WATERLOO METRO QUARTER DEVELOPMENT

Site Plan

RTS Changes

Elevation - South

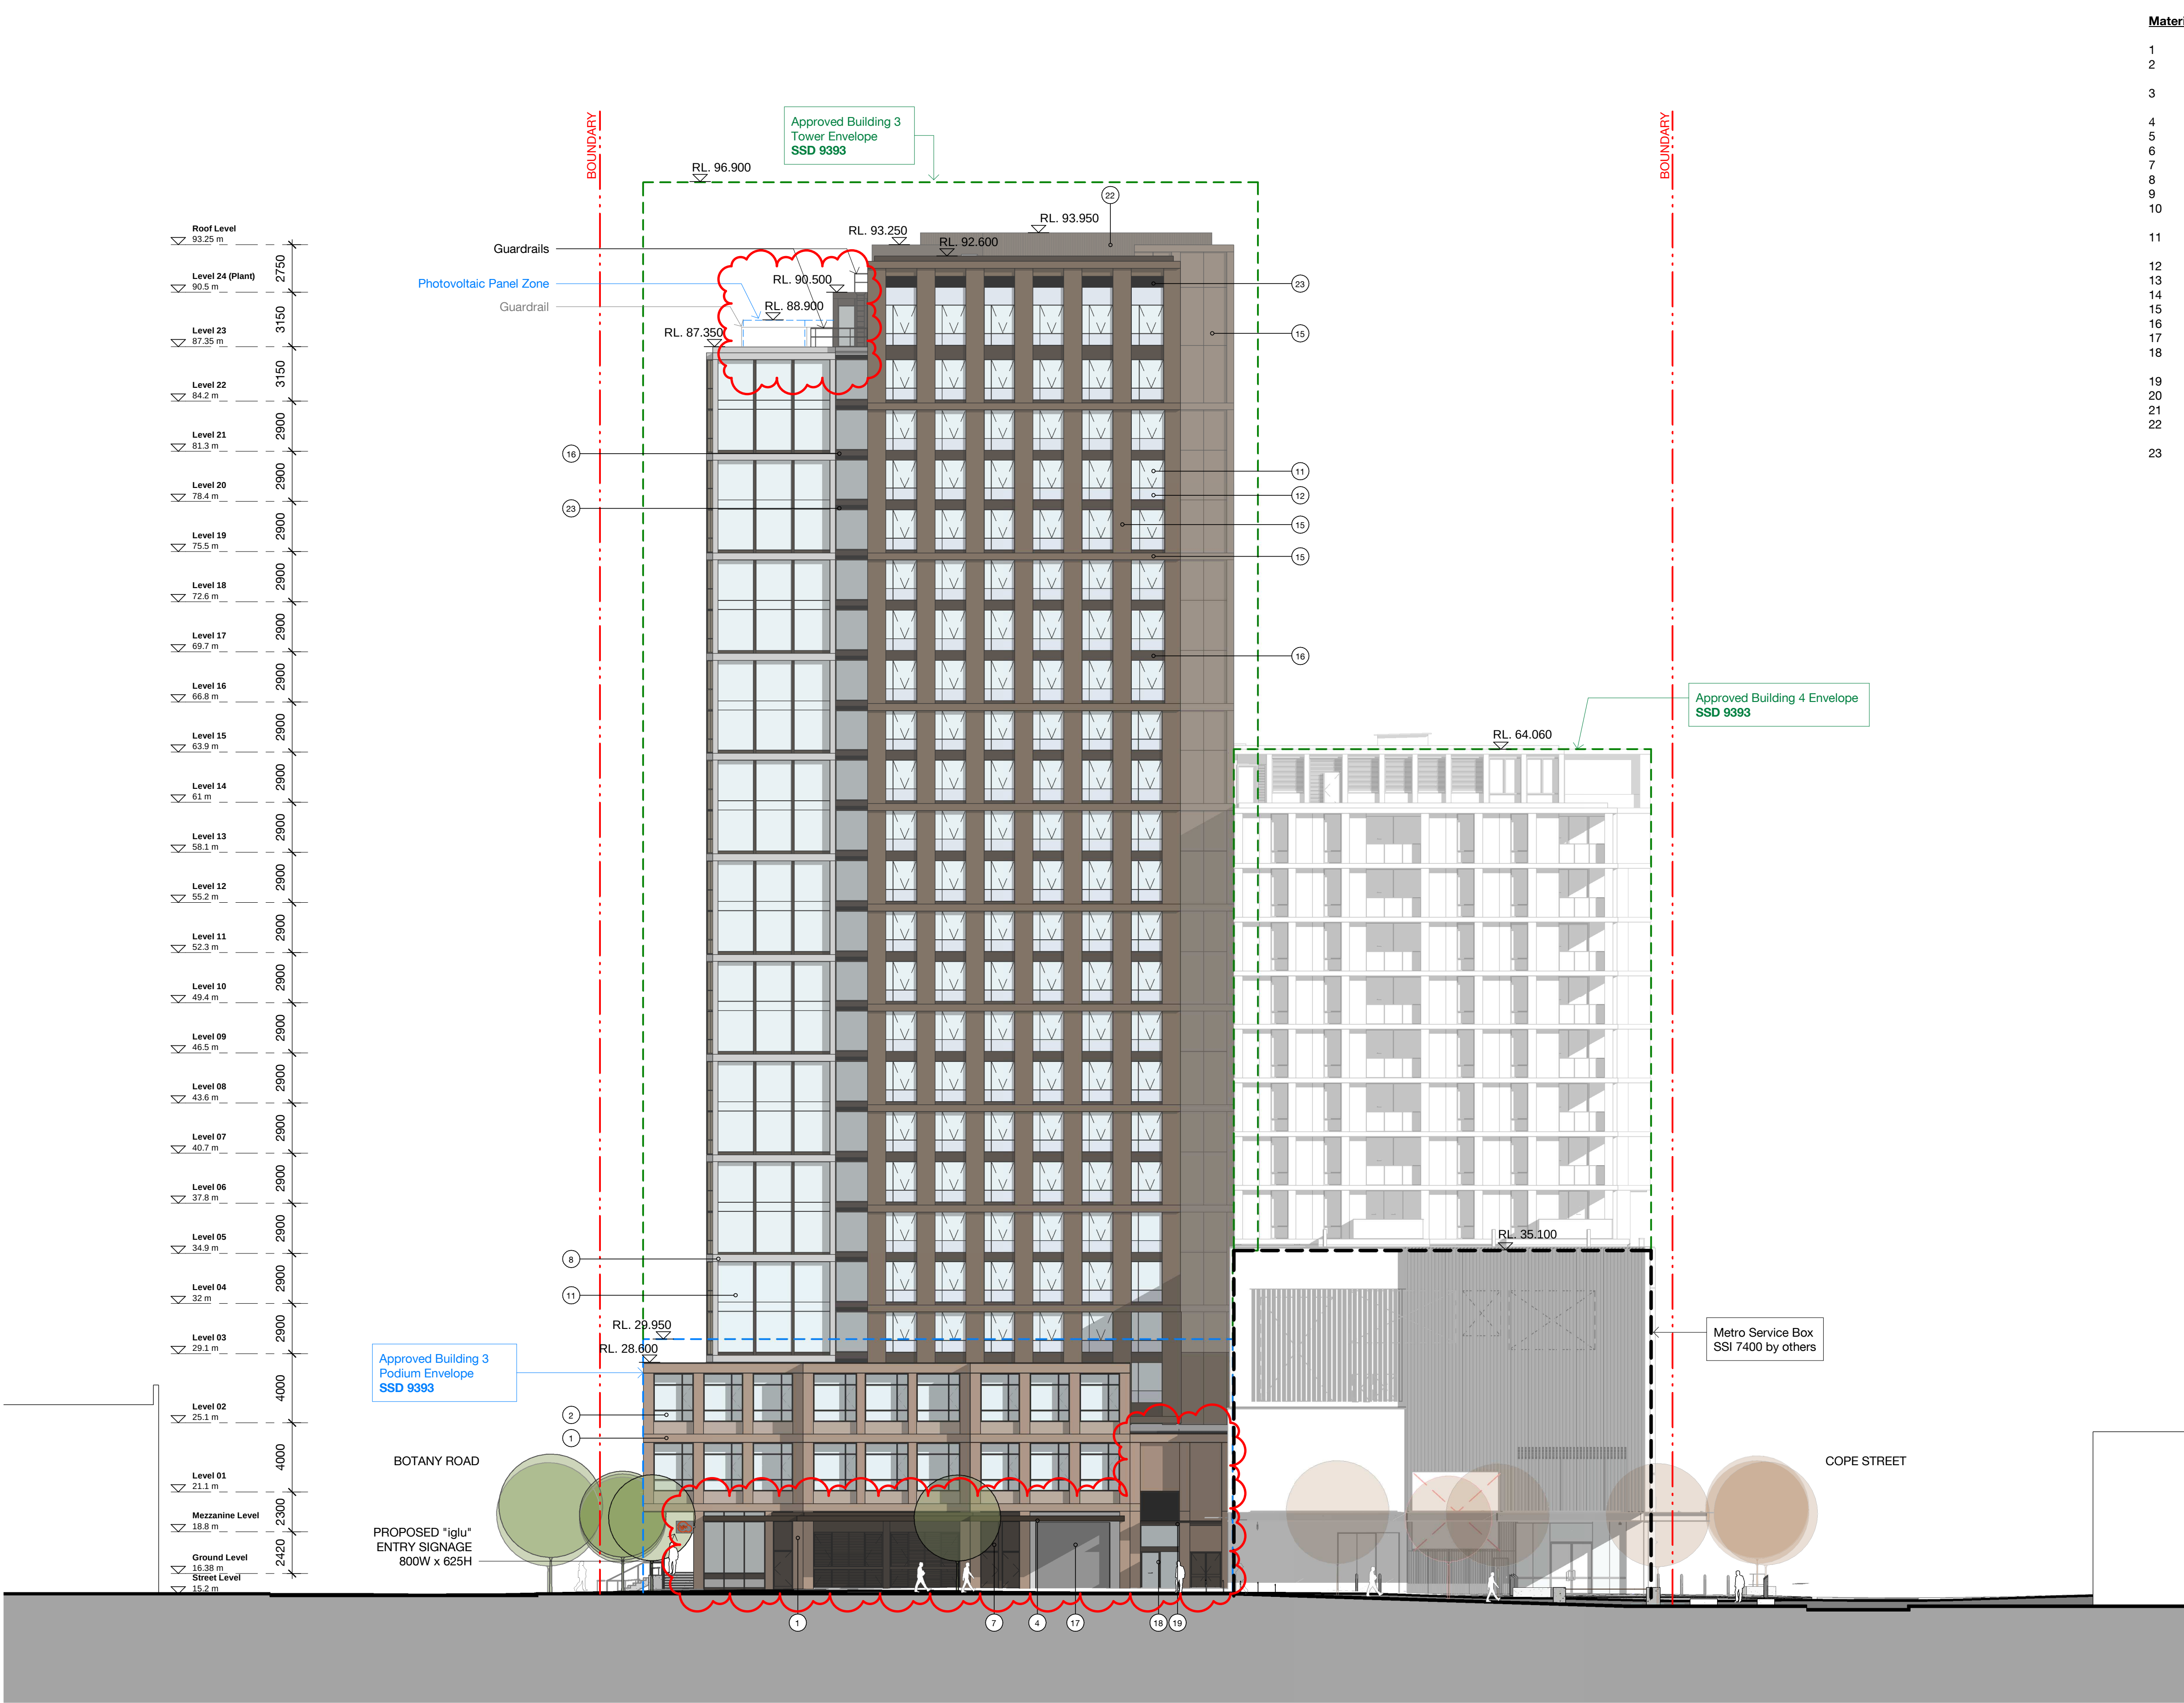
- Addition of Guard Rail
- Change to Social Housing Lobby Facade and Awning
- Change to Podium Southern Facade and Awning

Elevation - East

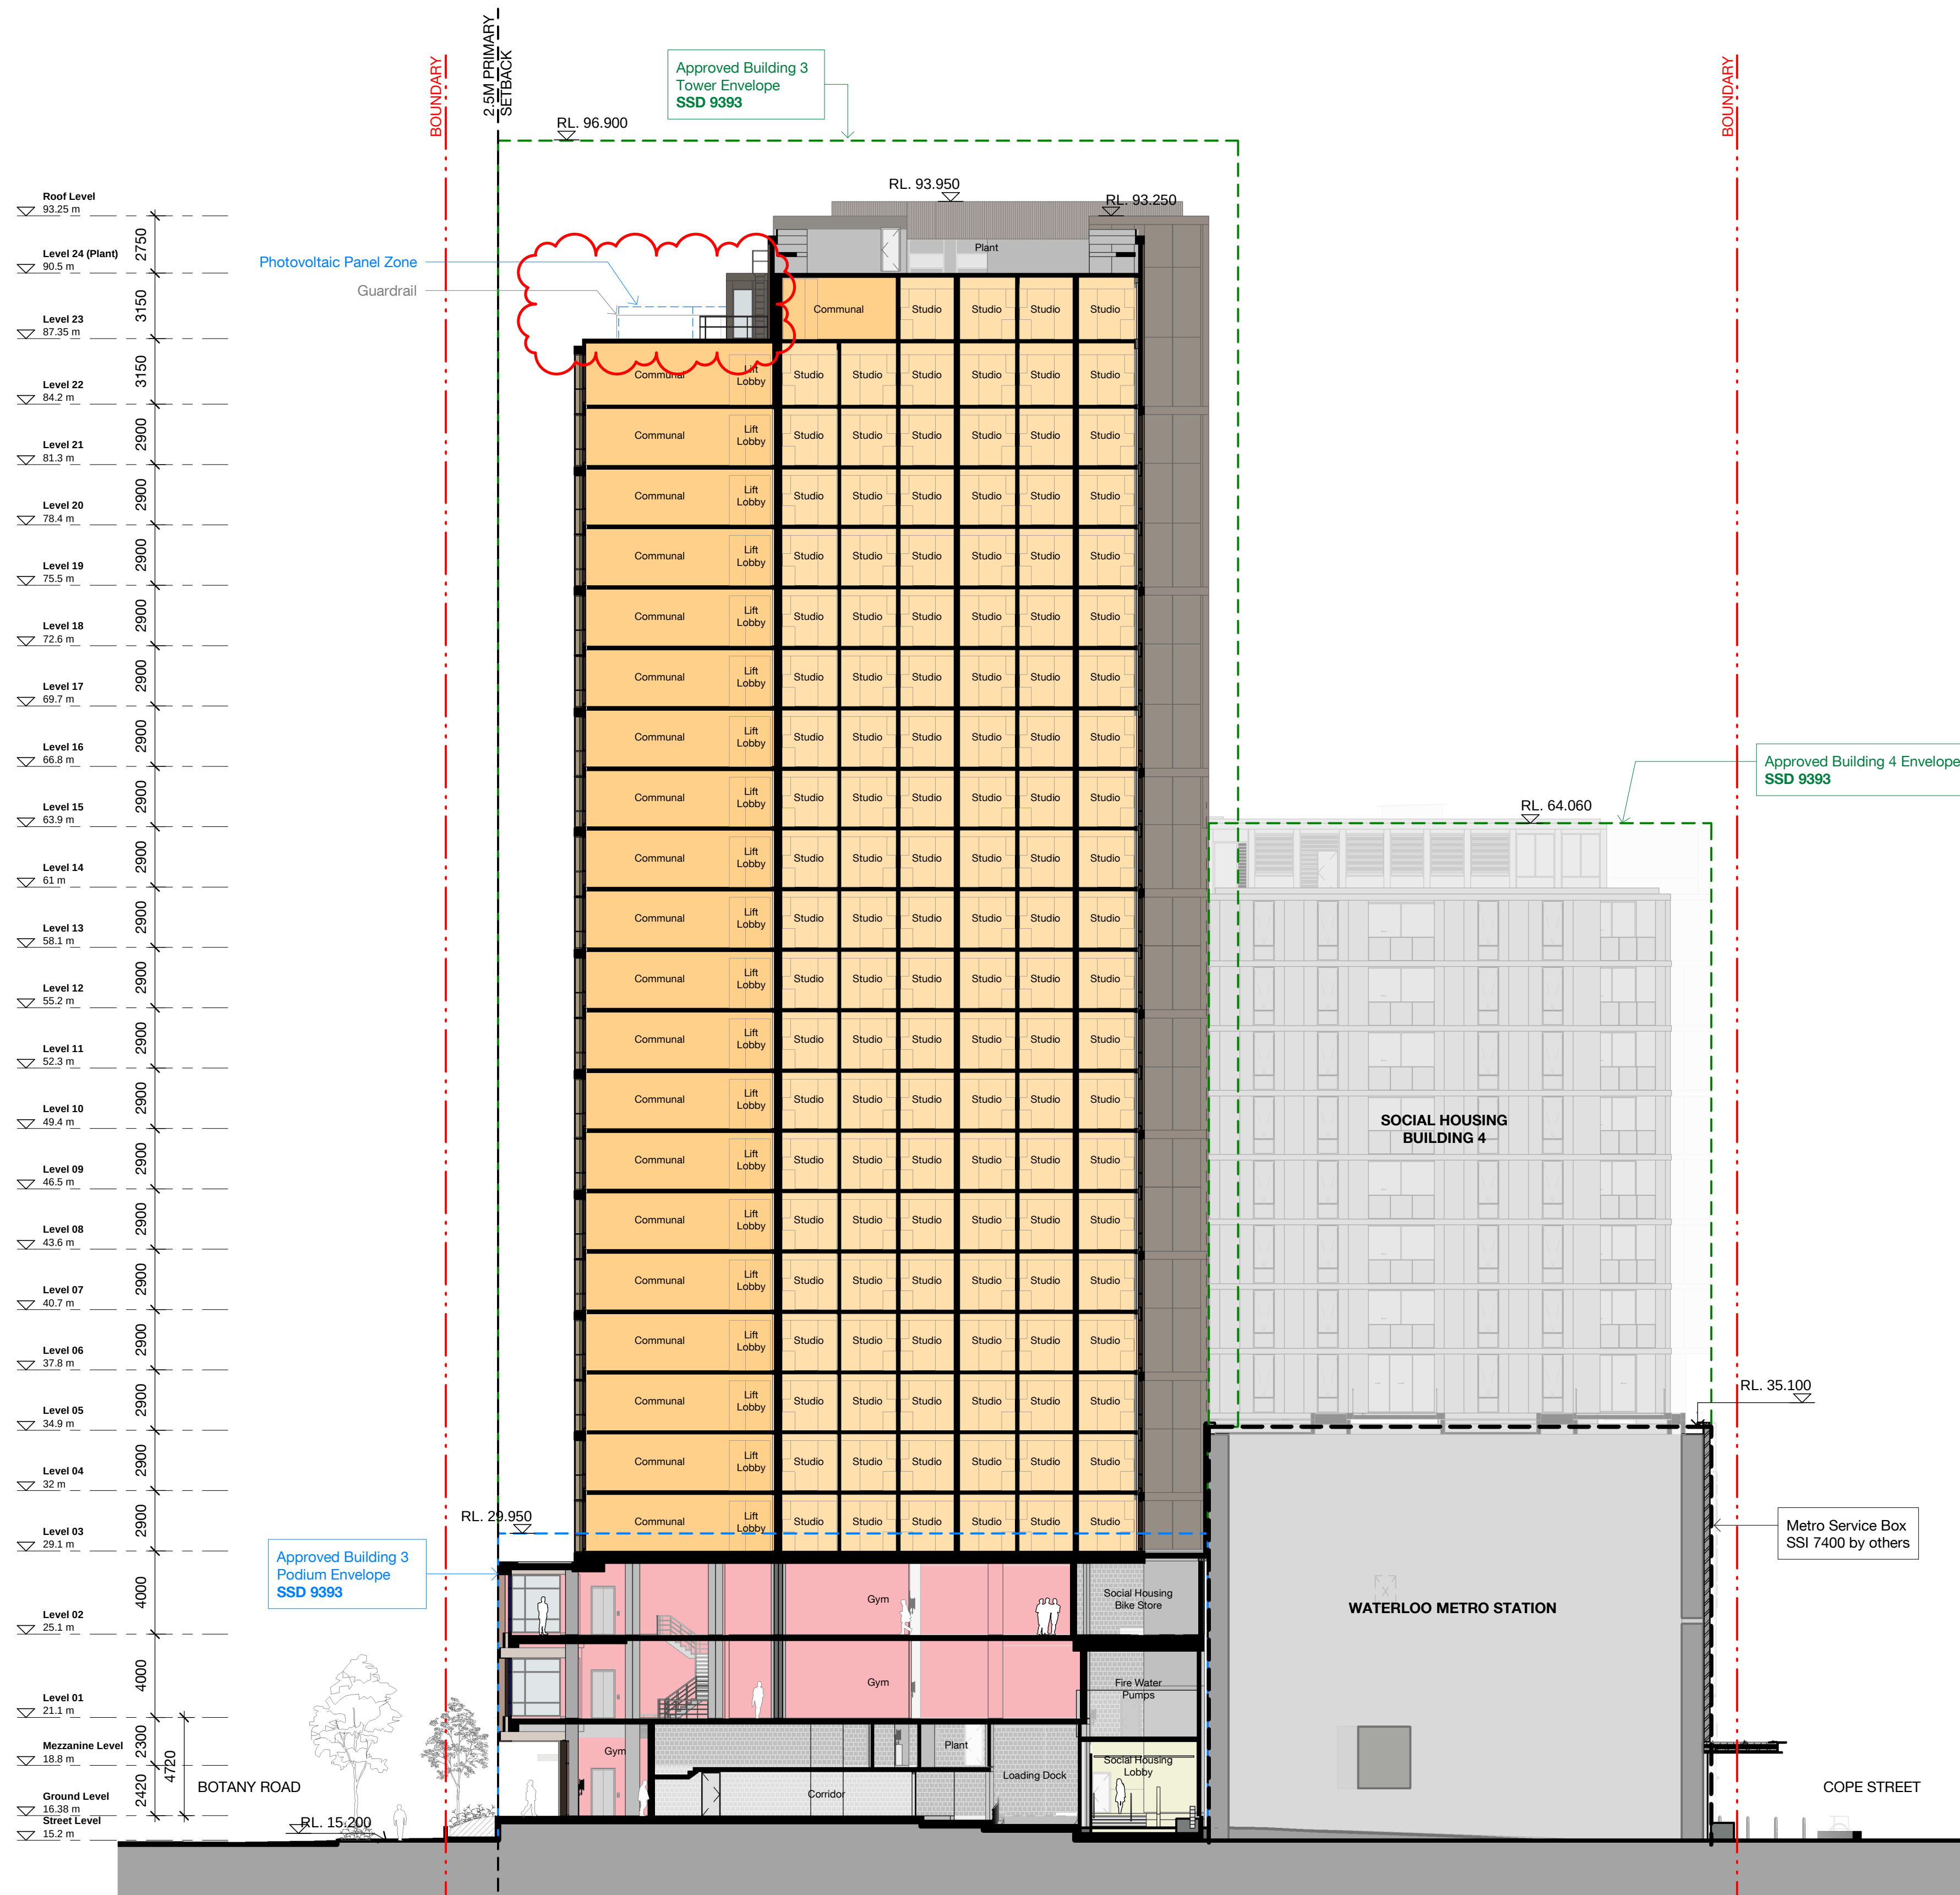
RTS Changes
• Change to Vertical Privacy Screen on Eastern Facade
• Guardrail for Photovoltaic Panel Zone Reinstated

Section E-W

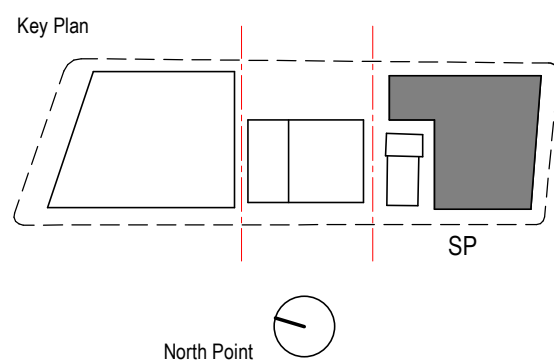
- Addition of Guard Rail
- Guardrail for Pohotovoltaic Panel Zone Reinstated

Section N-S

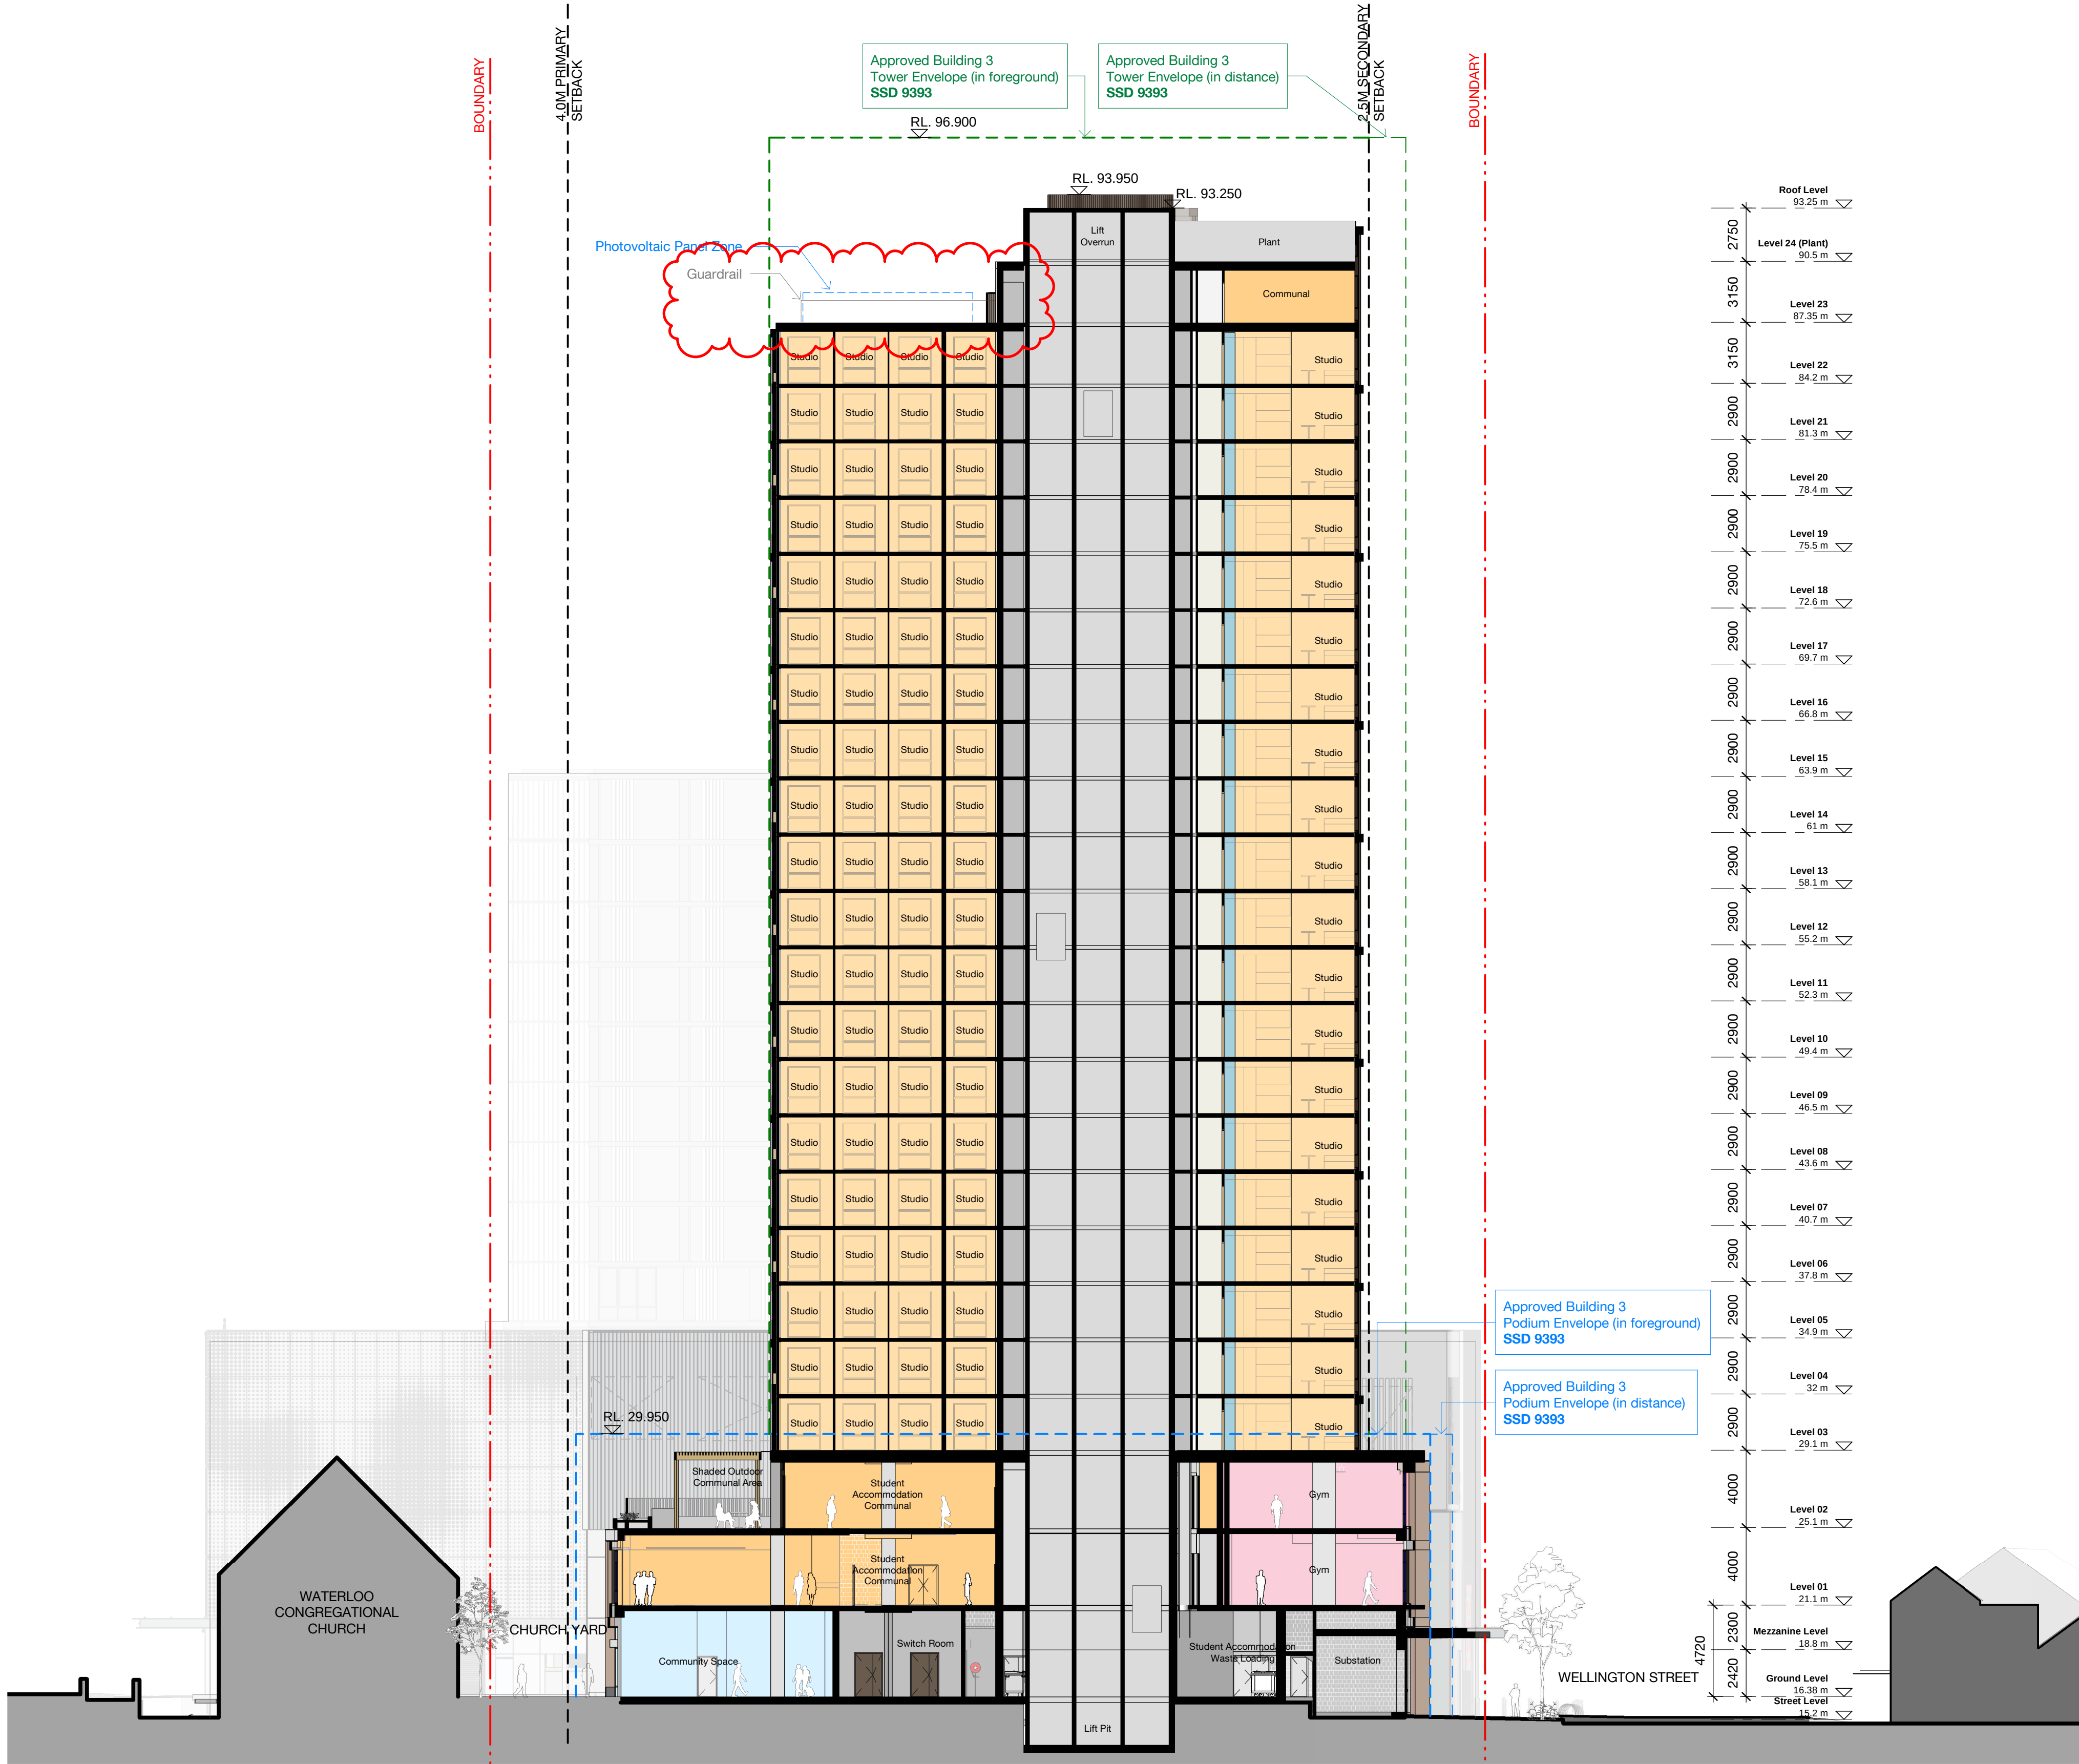
- Guardrail for Pohotovoltaic Panel Zone Reinstated
